MOORE SCHOOL OF ELECTRICAL ENGINEERING
UNIVERSITY OF PENNSYLVANIA

DC VOLTAGE CHART

CHART OF 3-1-47 — SEC. REVISION NO. 1 — DRAWING NO. PX-15-1002

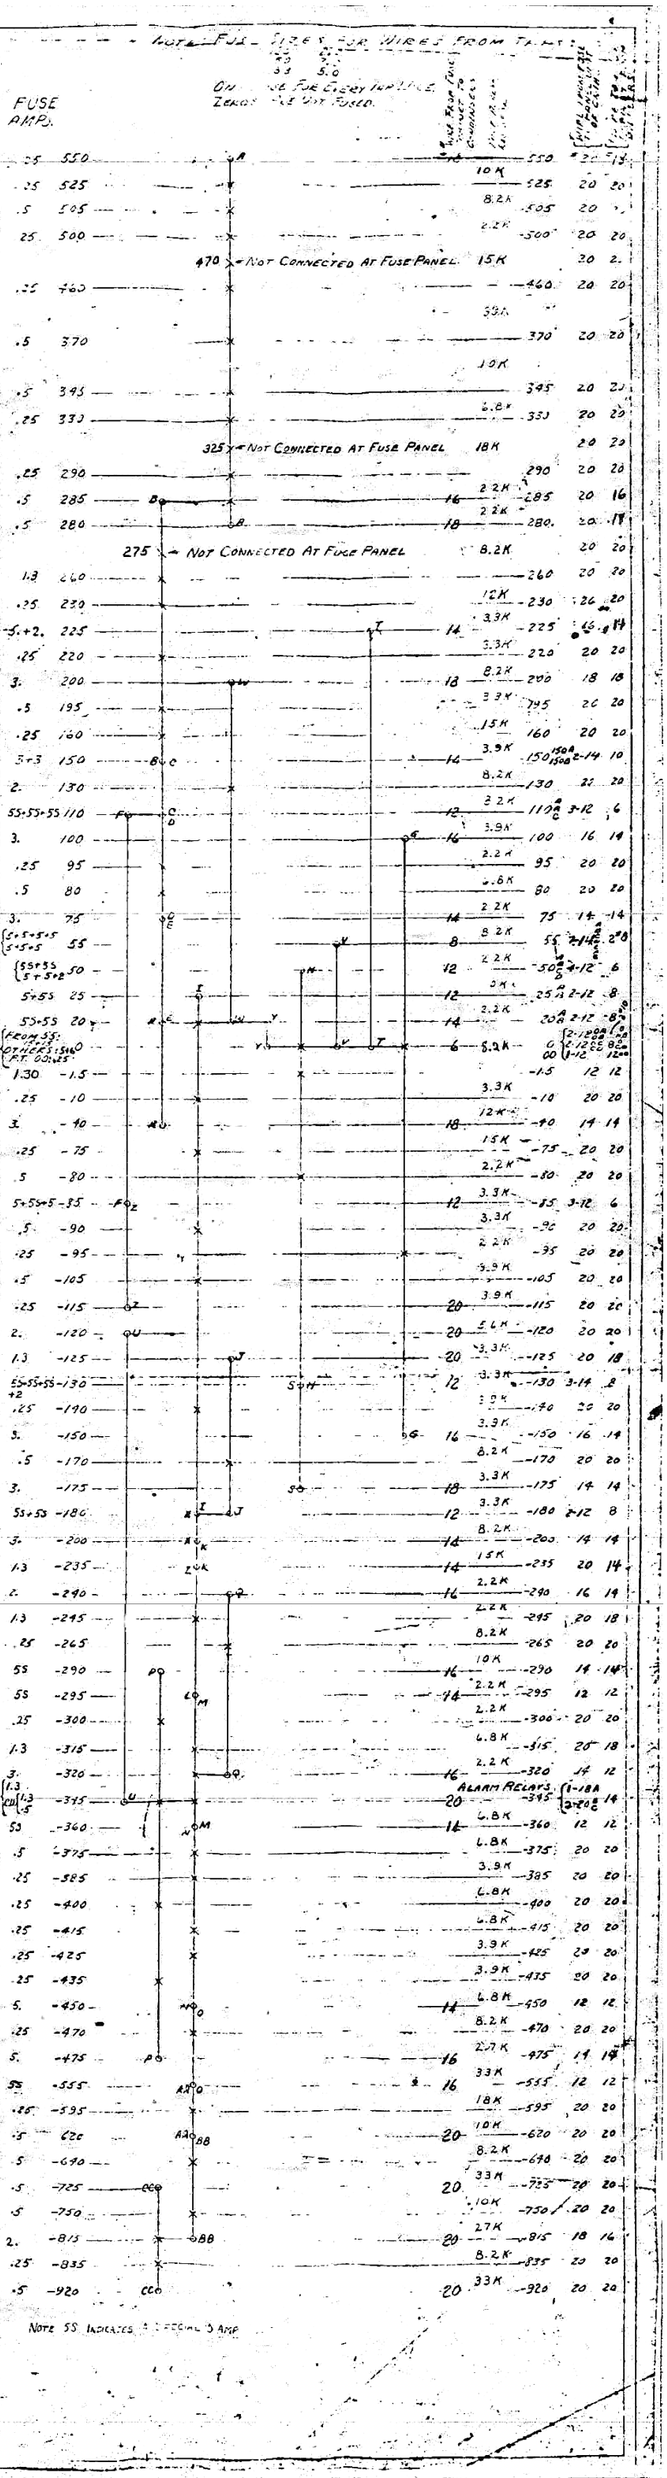
CHART REVISED & REDRAWN — AWB 3/14/45 — 1

1.33 FUSE NOW 1.0 — 220 NOW 270

+445 & +350 ADDED — WIRE SIZES & CONDUIT VALUES REVISED

RESISTORS FOR RELAYS ADDED — +275 CHANGED — AWB 8-22-45 — 4

CHANGED WIRE SIZES & ADDED WIRE SIZES FOR CAPACITORS — AWB 8-30-45 — 5

+270 CHANGED TO +260 — AWB 5-6-46 — 6

OBS ALARM CHANGED TO ABAMP OR NEW ALARM — AWB 7/14/47 — 8

470, 325, & 275 VOLTAGES ELIMINATED AT FUSE PANEL. FUSE-ALARM RESISTORS CHANGED ACCORDINGLY. ALARM RELAYS WERE BETWEEN +525 AND +550. — 11-12-48 — 9

FUSE AMP. SIZES CHANGED TO AGREE WITH VALUES NOW IN USE — 2-25-49 — 10

FUSE AMP SIZES CHANGED TO AGREE WITH VALUES NOW IN USE — 2-11-58 — 11
